This software updates or alters the functions and features noted below. The instructions and information that follow are meant as a supplement to the original instruction manual that accompanied the T18SZ/T16SZ/FX-36 transmitter. Please refer to the original instruction manual where applicable, but replace the steps indicated below with these instructions. Please check to ensure that the update has been installed.

This software updates or alters the functions and features noted below. The instructions and information that follow are meant as a supplement to the original instruction manual that accompanied the T16SZ transmitter. Please refer to the original instruction manual where applicable, but replace the steps indicated below with these instructions. Please check to ensure that the update has been installed.

Sensor type selection screen

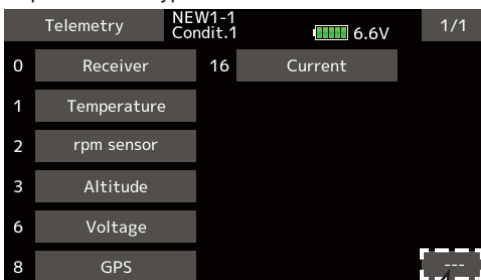
1. Telemetry display (The extension of the number of telemetry data which is shown)

The number of telemetry data which is displayed to Telemetry display screen is extended. It is 16 items (4 pages) maximum.

You can choose which type of sensor to displays. Tap the sensor type.

If you do not want to display telemetry data on the telemetry monitor screen, select "----".

Sensor selection screen

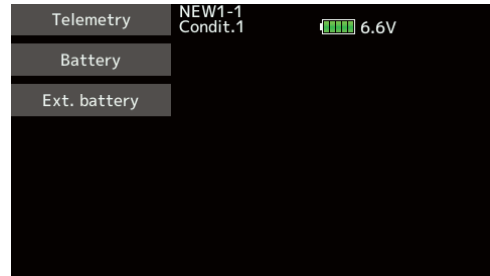
For some sensor types, you can choose the display item. Tap to select.

5. Butterfly Elevator setting (Glider)

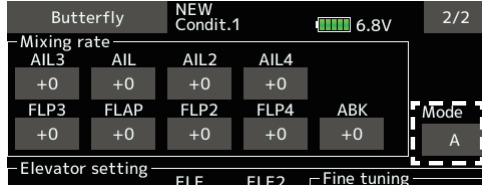
Added fine tuning function to butterfly elevator setting.

*When Flying wing type, it was made not to display Elevator setting.

• Mode A

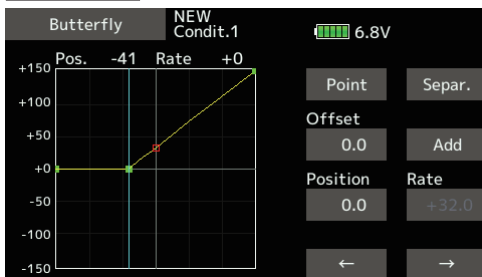
The operation of Butterfly mixing was changed.

Mode A, mode B selection added.

- The butterfly operation direction is reversed at the neutral position (50%) of the throttle stick.

The direction of butterfly motion is reversed.

• Mode B

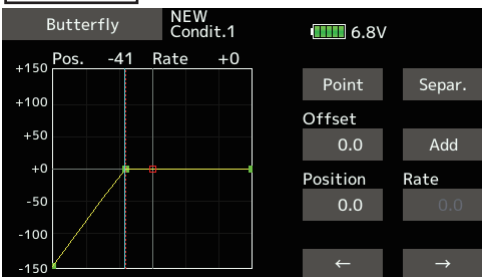
- It does not reverse at the neutral position, so you can set the butterfly operation start point with the full stroke of the throttle stick.

The direction of butterfly motion is not reversed.

7. Butterfly Differential rate (Glider)

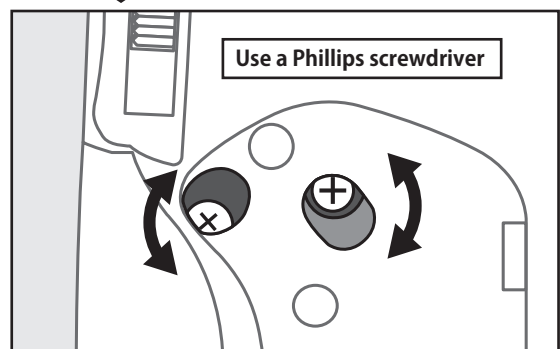
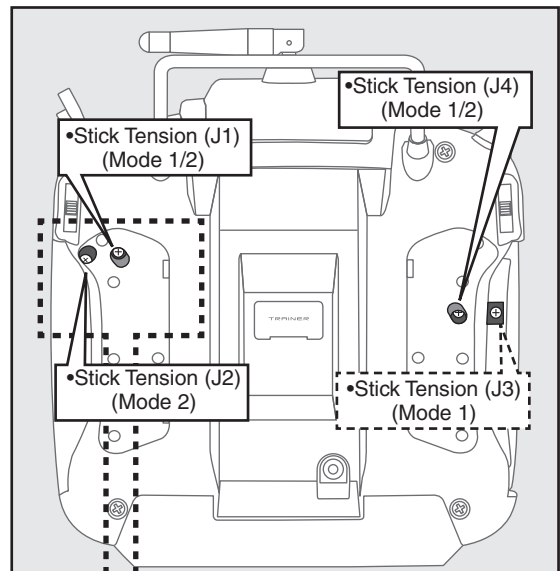
The operation of Butterfly Differential rate was changed.

- ◆ When Butterfly Differential rate is "+", Up rate is decrease and DOWN rate is increase.
- ◆ When Butterfly Differential rate is "-", the calculation method of UP/DOWN and a direction become reverse.
